RS-09-048

Subject: Response to Additional Questions Regarding Braidwood I3R-04, Request for Relief from 10 CFR 50.55a(g)(6)(ii)(E), Reactor Coolant Pressure Boundary Examination Scheduling Requirements in accordance with 10 CFR 50.55a(a)(3)(i)

**ATTACHMENT**  
**Response to Additional Questions Regarding Braidwood Relief Request I3R-04**

Figure 1. Comparison of Signal-to-Noise Ratio, Actual versus Manufactured Flaws. (The ultrasonic amplitude and echo-dynamic features were similar.)

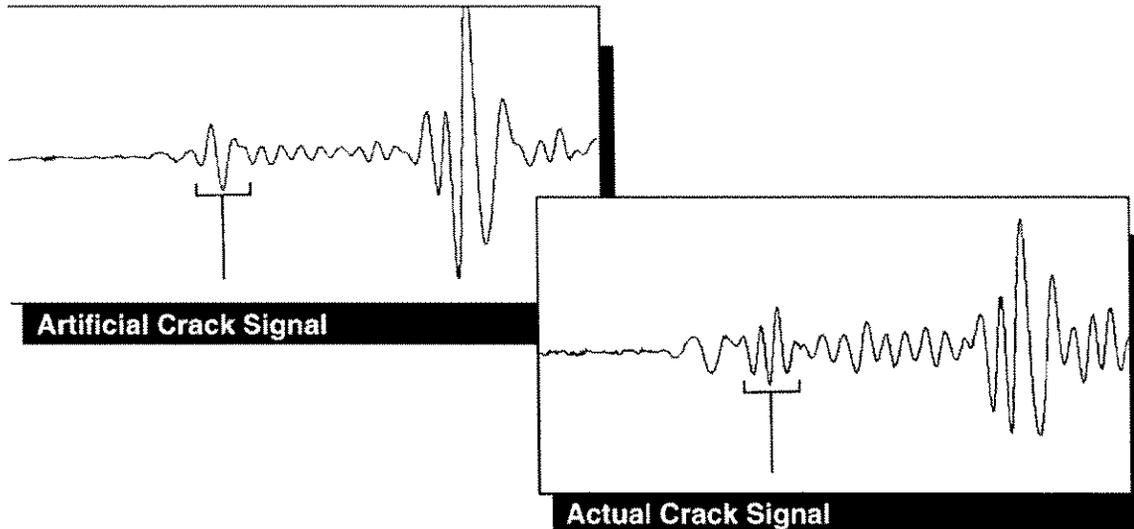
The response to Question 2.c. says, "the ultrasonic notch responses have been compared to a primary water stress corrosion cracking (PWSCC) flaw at the Bugey plant, as shown in the figures below." The licensee should describe the crack signals they are presenting. For example, the licensee should describe what type of scan is being presented, what is being compared, and what conclusion is reached.

Additional information was provided to the NRC the week of March 9, 2009, when they visited the EPRI offices in Charlotte. The flaws are made with squeezed electro-discharge-machined (EDM) notches (not implants), which have been squeezed via the cold isostatic pressing (CIP) process.

Typically, the radius of the squeezed CIP EDM notch tips used in CRDM and BMI flawed mockups are 10 microns, which is smaller than that required by ASME Section XI, Appendix VIII. When the ultrasonic test (UT) CIP squeezed EDM notch responses were compared with a PWSCC flaw from Bugey, they were found to give similar UT forward scatter time-of-flight-diffraction (TOFD) responses.

The amplitude of the ultrasonic tip responses varied only slightly. Differences when averaged over the length of the flaw did not vary more than +/- 2 dB. This was determined to be primarily due to minor variations in surface condition and ultrasonic coupling.

As can be seen in Figure 1 below, the signal-to-noise ratios were also very similar. The average signal-to-noise ratio observed was 3-to-1. The similarity in the phase angles of the simulated and field-removed cracks can also be seen. There was no negligible difference observed between the echodynamic characteristics of the simulated and field-removed cracks as seen in Figure 1 below and documented in a publicly available EPRI Technical Report TR-106260 (Reference 1).
